CERTIFICATE OF APPROPRIATENESS

Property: Section 4 Lot 8 Block 12, Glenbrook Valley Subdivision. The property includes an historic one-story wood frame 1,193 sq. ft. single-family residence situated on an 8,400 sq. ft. interior lot.

Proposal: Alteration – Windows.

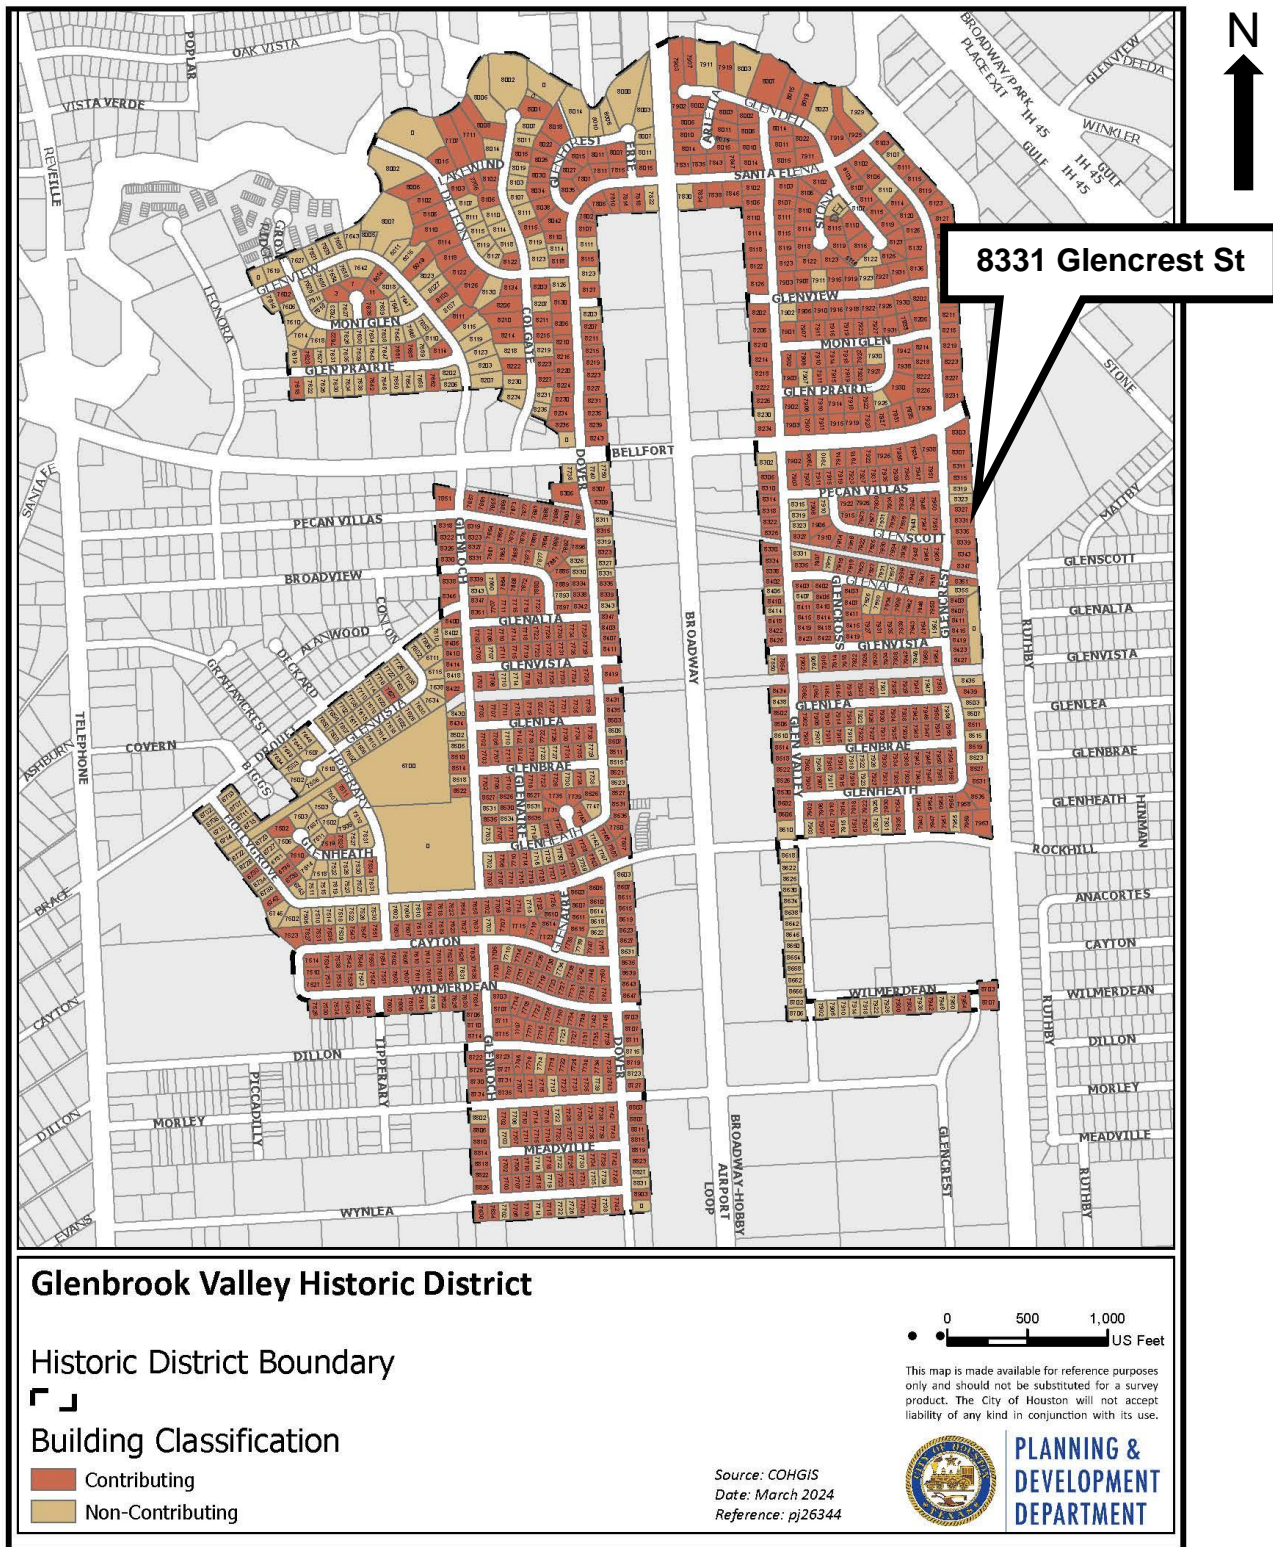
ALL NEW WINDOWS MUST BE INSET 1¾ Inches – See Attachment 1

From Face of Exterior Casing to Face of Window Unit Shall be 1¾ inch Minimum
